# Access Compliance Report

## Public Rights-of-Way

### (Curb Ramps)

Intersection ID: 53399	Main Street: COWGILL_LN	Cross Street: AGNEW_DR	Location: NW
ADA ID: DED7C3D8B619	Ramp Type: Perp	Initial Pass/Fail: Fail	Overall Compliance: No
Severity Score: 8.75			
Codes/Mitigation Info/Possible Solution		Field Measurements/Component Compliance

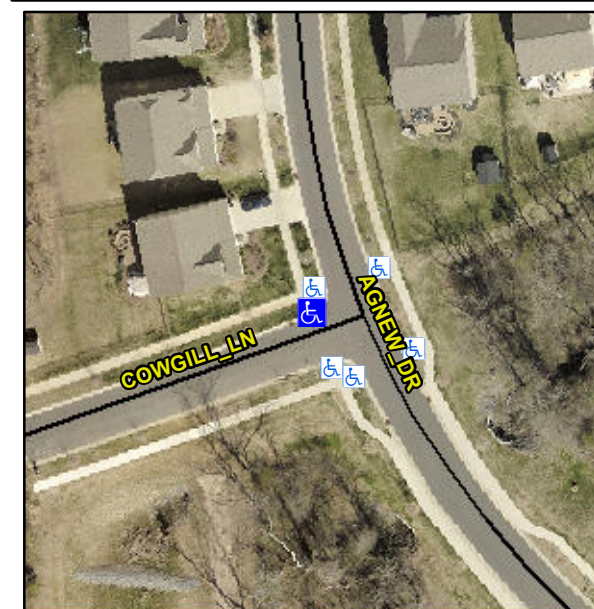
**Not Found, R304.5.1**

Compliance	Description	Data	Compliance	Description	Data
N/A	Ramp Length (in)	99.0	Yes	Ramp Slope (%)	8.1
No	Ramp Width (in)	45.0	Yes	Ramp XSlope (%)	1.1
N/A	Flare Type LT	N/A	N/A	Flare Type RT	N/A
N/A	Flare Slope LT (%)	N/A	N/A	Flare Slope RT (%)	N/A
N/A	Flare Traversable LT?	N/A	N/A	Flare Traversable RT?	N/A
N/A	Landing Length (in)	N/A	N/A	DWS Provided?	N/A
N/A	Landing Width (in)	N/A	N/A	DWS Contrast?	N/A
N/A	Landing Slope (%)	N/A	N/A	DWS Length (in)	N/A
N/A	Landing X Slope (%)	N/A	N/A	DWS Full Width?	N/A
N/A	Landing Curb? (Y/N)	N/A	N/A	DWS Offset (in)	N/A
N/A	Shared Landing?	N/A			
N/A	Gutter Ponding?	N/A	N/A	Gutter Slope (%)	N/A
N/A	Gutter Lip Ht (in)	N/A	N/A	Gutter X Slope (%)	N/A
N/A	Painted X Walk1?	No	N/A	Painted X Walk2?	N/A
	X Walk 1 Direction	To SE		X Walk 2 Direction	N/A
N/A	X Walk 1 Width (in)	N/A	N/A	X Walk 2 Width (in)	N/A
	X Walk 1 Slope (%)	1.3		X Walk 2 Slope (%)	N/A
	X Walk 1 X Slope (%)	1.3		X Walk 2 X Slope (%)	N/A

**Remove & Replace Entire Ramp.**
